Access Compliance Report

Public Rights-of-Way

(Pedestrian Signals)

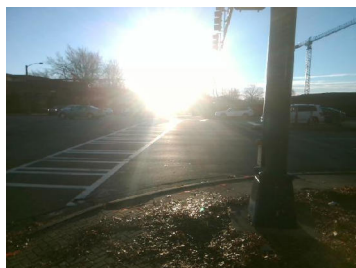
PROW/ADA: R209.1, TMUTCD 4e.08, R404.2, R404.3, R404.7.1, R404.7.2

N/A	B 1 Clear Xing Direction?	N/A	N/A	B 2 Clear Xing Direction?	N/A
	B 1 Crossing Direction	To SE		B 2 Crossing Direction	N/A
No	B 1 DistanceTo XWalk (in)	140.0	N/A	B 2 DistanceTo XWalk (in)	N/A
No	B 1 DistanceTo Curb (in)	121.0	N/A	B 2 DistanceTo Curb (in)	N/A
Yes	B 1 Diameter (in)	2.0	N/A	B 2 Diameter (in)	N/A

Possible Solutions: Replace Signal Push Button With APS Button on New Post. Remove & Replace Sign.
